Sent: 13/05/2022 1:14:03 PM
Subject: FW: Objection to DA 2021/1636 Clause 4.6 Submission to Vary Height of Buildings above Maximum
Attachments: Clause46_Variations.pdf;

Objections to Amended Clause 4.6 Submission Dated 3 May 2022

8.5m Maximum Building Height Based on Existing Ground Level using DA's survey points

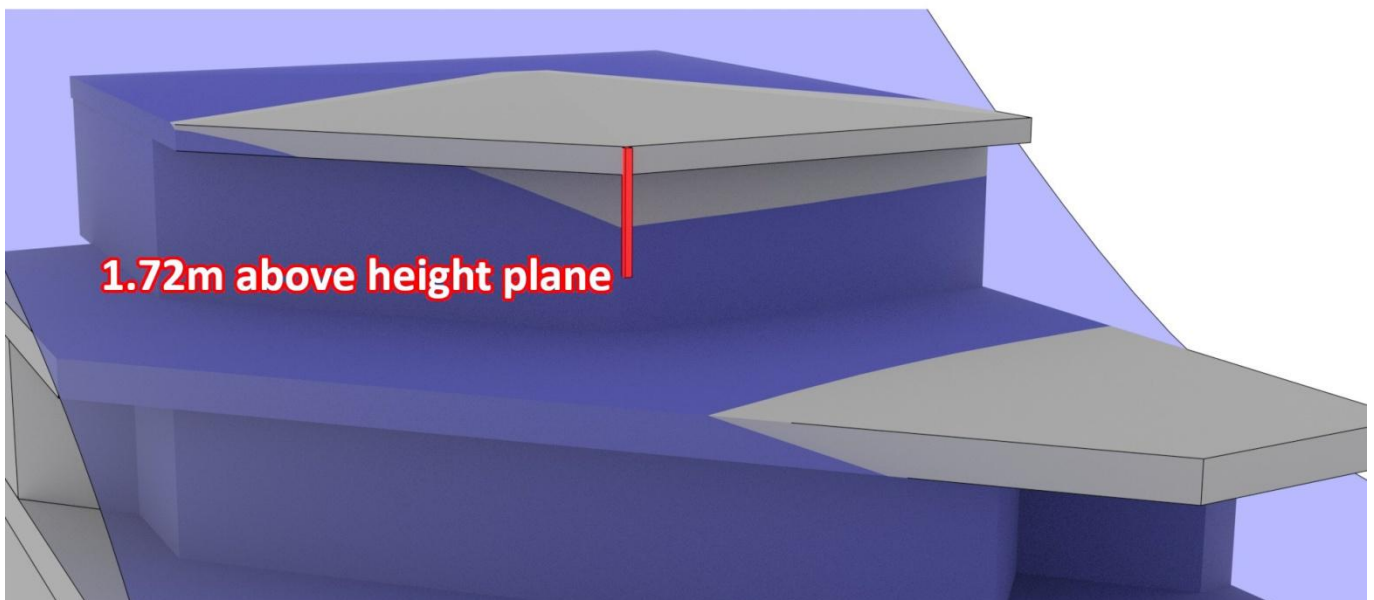
The claim of 8.6 metres is incorrect. It is **not** based on the DA's surveyed levels as claimed. **The DA does not use its own survey plan data points, from 3 sides around the building.** The proposed works have a maximum height above existing ground level of 10.22 metres. **This exceeds the standard by 1.72 metres, or 20%.** The non compliance can be seen from the red height pole in the 3D height plane drawing below.

Our height plane is based on survey points **taken directly from the DA's survey plan**. Multiple survey points at the existing ground level at the East, South and West sides of the building have been used. Points on the South and West are from the top of the existing rubble fill. The East side is an unexcavated and unmodified relatively flat natural rock shelf. There is no "challenge" in using the DA's own survey. If "an abundance of caution" should be used in using the survey data submitted by the DA, perhaps "caution" should be used in assessing other DA claims.
